# UNITED STATES PATENT AND TRADEMARK OFFICE

APPLICATION NO.	FILING DATE	FIRST NAMED INVENTOR	ATTORNEY DOCKET NO.	CONFIRMATION NO.
10/769,920	02/03/2004	Shinji Hayashi	086142-0633	9767
22428	7590	09/07/2007	EXAMINER	
FOLEY AND LARDNER LLP			SLITERIS, JOSELYNN Y	
SUITE 500			ART UNIT	PAPER NUMBER
3000 K STREET NW			3616	
WASHINGTON, DC 20007				
			MAIL DATE	DELIVERY MODE
			09/07/2007	PAPER

<b>Office Action Summary</b>	<b>Application No.</b>	<b>Applicant(s)</b>
	10/769,920	HAYASHI ET AL.
	<b>Examiner</b> Joselynn Y. Sliteris	<b>Art Unit</b> 3616

FIG. 4 A

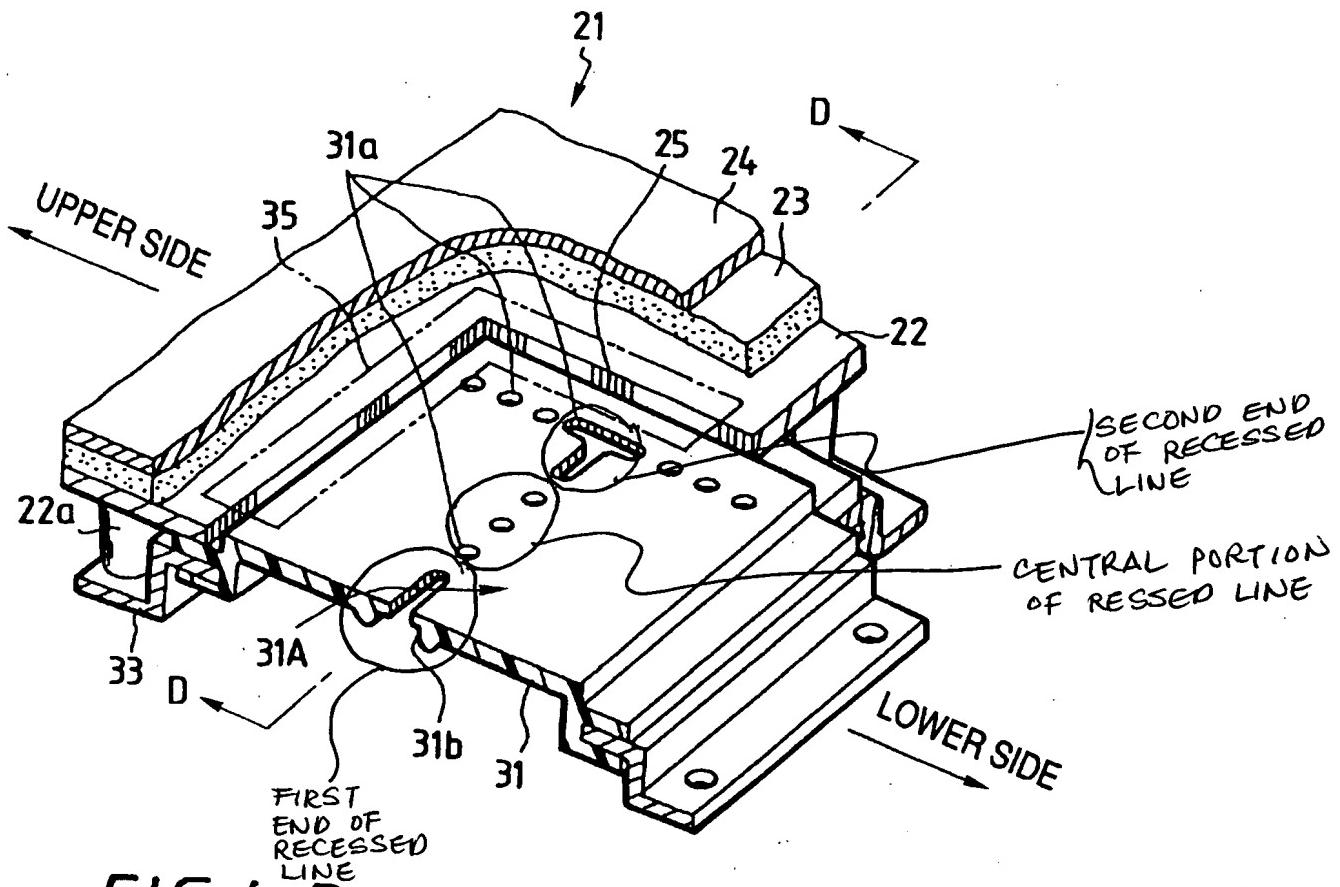
6. Regarding claims 29-32, 34-37, and 43, Uehara discloses a method of making a cover component 31A (Figs. 4A, 4B) mountable to an airbag system, as in the present invention, the cover component having a tear line 31a, 31b that is torn open when an airbag of the airbag system inflates, comprising:

molding said moldable material using said die so as to form a molded material having a recessed line 31b corresponding to said raised line, the recessed line extending in a line and having a first end, a central portion with opposing sides, and a second end (see annotated Figs. 4A, 4B attached);

wherein the tear line 31a, 31b extends in an H shape (Figs. 1A, 4A);

wherein the tear line extends in an H shape (Figs. 1A, 4A);

However, examiner disagrees. Examiner points out that "FIG. 4B is a section view taken along the line D-D of FIG. 4A" as disclosed by Uehara in the "Brief Description of the Drawings". Therefore, the "angle" or slope is shown at the first or second end of the recessed line", in addition to a line located on one of the opposing sides of a groove as can be easily seen in Fig. 4A.

FIG. 4 B

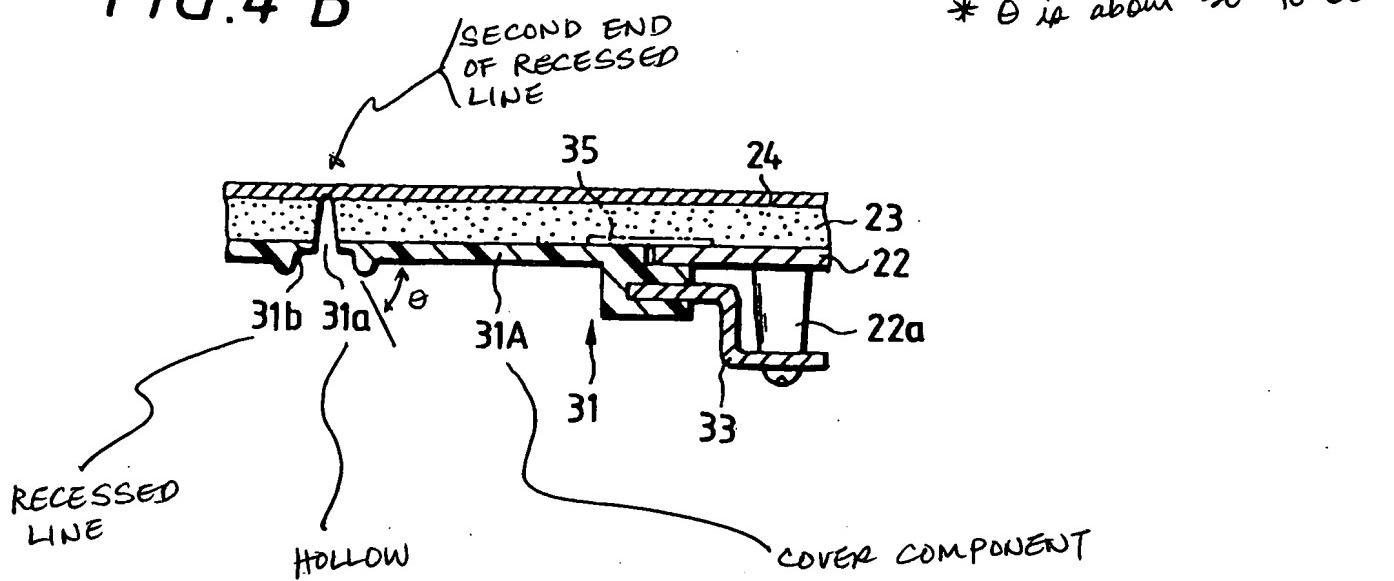
wherein the bottom recess of the recessed line near the first or second end of the recessed line is molded to form a slope about 30° to 60° inclined relative to the back of the cover component (see annotated Fig. 4B attached);

wherein the bottom recess of the recessed line near the first or second end of the recessed line is formed in a slope about 30° to 60° inclined relative to the back of the cover component (see annotated Fig. 4B attached).

13. Applicant argues, in particular, that the "angle or slope allegedly disclosed in Figure 4B is not at the "first or second end of the recessed line." Rather, the annotation on Fig. 4B is a line located on one of the opposing sides of a groove not a first or second end. Thus, Uehara fails to anticipate claim 1".

FIG. 1

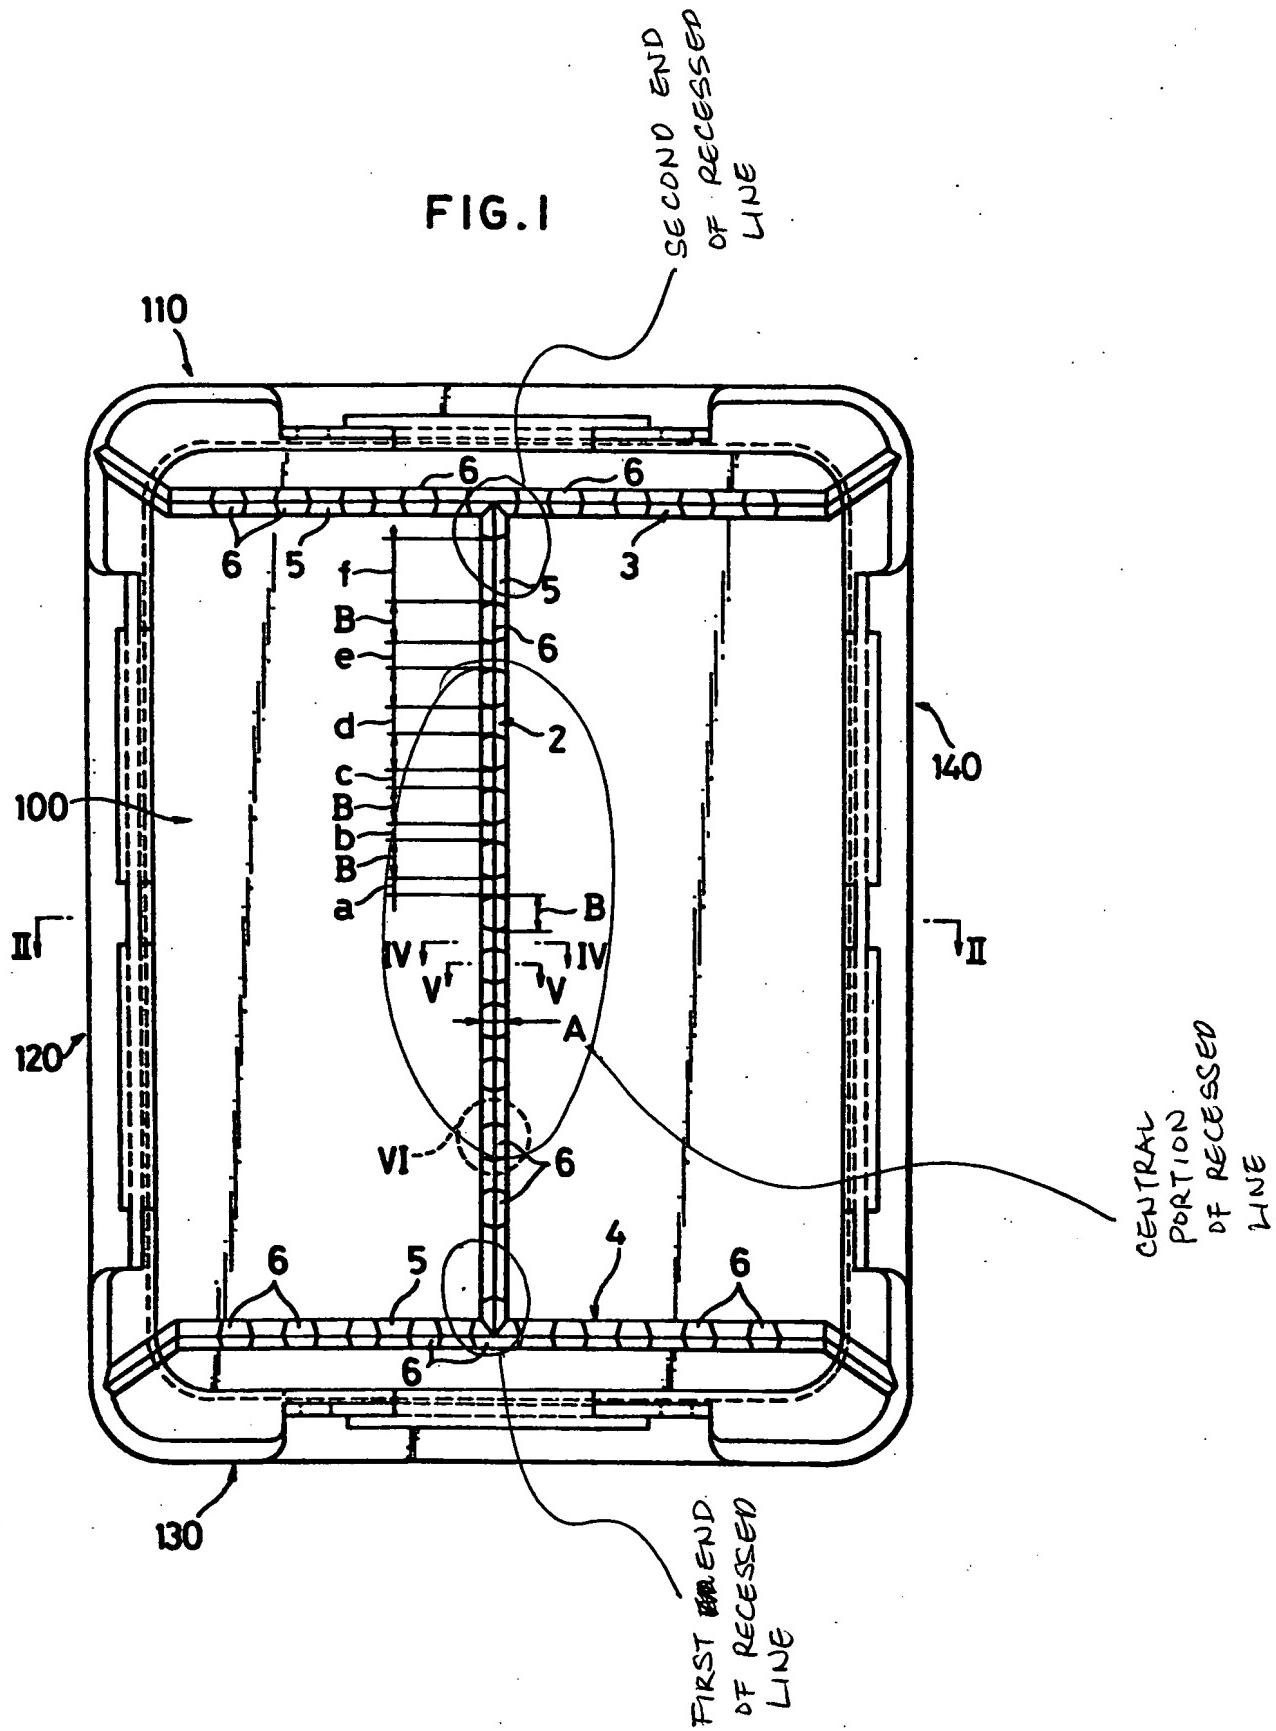
molding said moldable material using said die so as to form a molded material having a recessed line 5 corresponding to said raised line, the recessed line extending in a line and having a first end, a central portion 2 with opposing sides, and a second end (see annotated Fig. 1 attached);

wherein the tear line 2-4 extends in an H shape (Fig. 1);

forming a recessed line 5 at least in a part of the tear line by using a raised line provided on a core surface of a die when the cover component is molded, the recessed line extending in a line and having a first end, a central portion 2 with opposing sides, and a second end (see annotated Fig. 1 attached); and

wherein the tear line extends in an H shape (Fig. 1);

Again, examiner disagrees. Examiner points out that although Figure 4 discloses a sloped central portion of a recessed line, the slope of the recessed line at the first and/or second end would be applicable as well because of tear lines 3 and 4, which can be seen in Fig. 1.

FIG.2

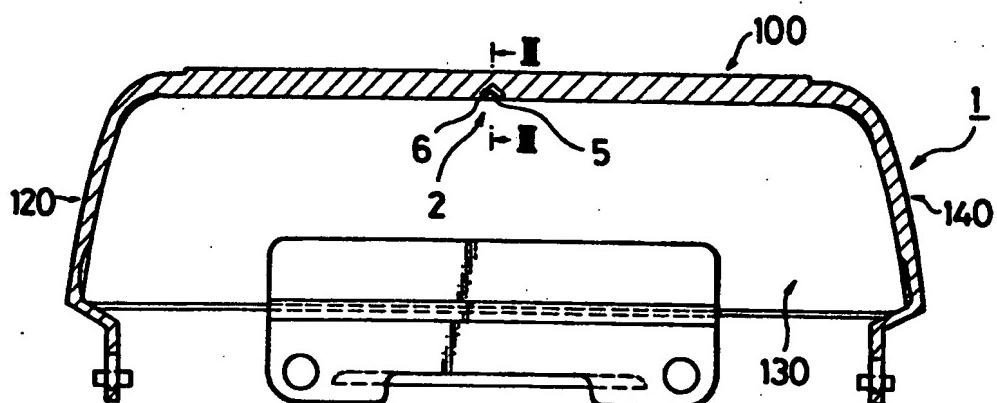
a plurality of hollows 6 in said recessed line along the central portion in said molded material at intervals (Figs. 2, 3);

hollows 6 in the recessed line at intervals (Figs. 2, 3);

FIG.4

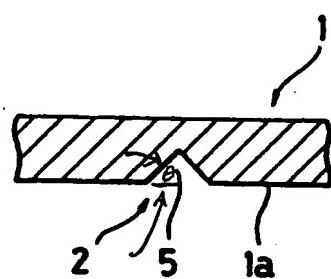
wherein a bottom recess of the recessed line at the first or second end of the recessed line is molded to form a slope inclined relative to a back of the cover component (see annotated Fig. 4 attached);

wherein the bottom recess of the recessed line near the first or second end of the recessed line is molded to form a slope about 30° to 60° inclined relative to the back of the cover component (see annotated Fig. 4 attached);

wherein the recessed line decreases in depth gradually toward the first or second end of the tear line (Fig. 4);

wherein a bottom recess of the recessed line at the first or second end of the recessed line is molded to form a slope inclined relative to a back of the cover component (see annotated Fig. 4 attached);

wherein the bottom recess of the recessed line near the first or second end of the recessed line is formed in a slope about 30° to 60° inclined relative to the back of the cover component (see annotated Fig. 4 attached);

15. Applicant argues, in particular, that the "Examiner contends that Figure 4 of Sawada discloses a recessed line molded to form a slope. See Office Action at p. 6. However, Figure 4 of Sawada merely discloses a sloped central portion of a recessed line and not a first or second end. See Figure 4 of Sawada and see Figure 3 of Sawada. Uehara fails to cure the deficiencies of Sawada. Thus, reconsideration and withdrawal of the rejection should be withdrawn."
